District Response to the Crystal River/Kings Bay MFLs Peer Review

February 21, 2017

CRYSTAL RIVER/KINGS BAY
MINIMUM FLOW AND LEVEL
PEER REVIEW

Figure 1. Mean daily discharge of Crystal River near Crystal River for select days, 1983-85.

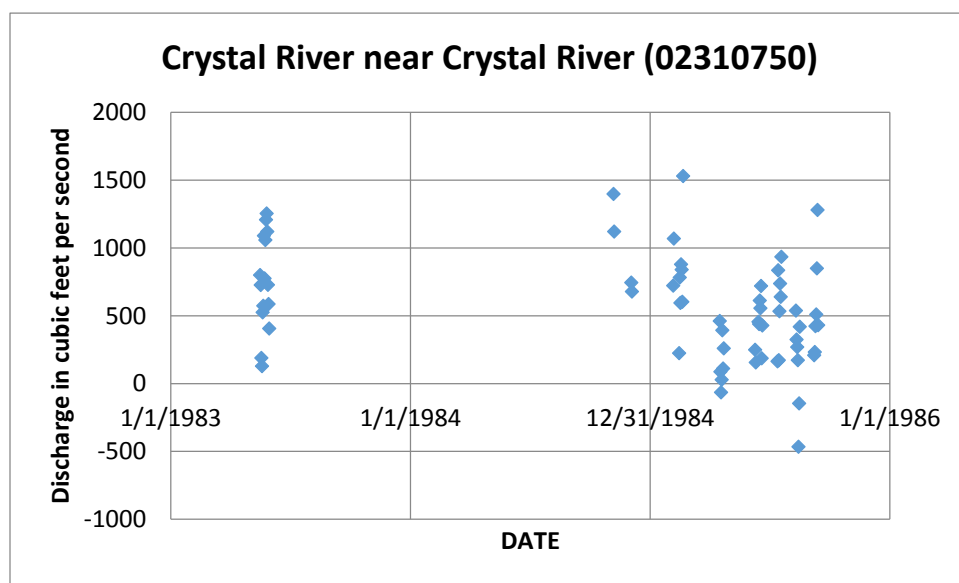
One, I’m concerned about the calculation of negative flow into the springs without convincing field evidence to support this hydrologic condition. The field data presented in this report do not support your hypothetical model results presented at our July 25, 2014 of reverse (negative) flow into the springs. Table 1 of the technical memo (see below) contain no negative values for measured spring flow indicating that negative spring flows were not observed during the data collection period from July 28 through October 8, 2009. However, figure 15 found in this report and enclosed with this memo, shows that negative discharges occur about 10 percent of the 60-day record (August 22, 2007 to October 20, 2007). My concerns regarding spring flow reversals were dismissed in the response memo stating “spring flow can be temporary negative and data indicating this phenomenon occurs in Kings Bay are available” but no data or real ground-water system analysis of this phenomenon is presented.

Discharge data for Crystal River (02310750) were computed by the USGS from 1965 to 1977 and for periodic days in 1983-85 (fig.1). A deflection (vane) meter was used from 1965-77 and an advanced acoustic velocity meter was in use during 1983-85 to provide an index to calculate discharge. Calculated mean discharge of Crystal River across this section was highly variable ranging from about 507 to 975 cubic feet per second (table 2). The higher values of 975 and 916 ft³/s were calculated from 13 and 11 mean annual discharges, respectively (Yobbi and Knochenmus, 1989; Rosenau and others, 1977). Discharge calculated at this site using the more precise acoustic velocity-index method for 65 periodic days in 1983-85 (fig. 1) was 534 (441 ft³/s lower than in 1965-77). Based on 50 days of record, mean discharge for water year 1985 was 507 ft³/s while the mean annual water level in the Weeki Wachee well was 0.5 ft higher in 1985 than during the 13-year period from 1966-77.
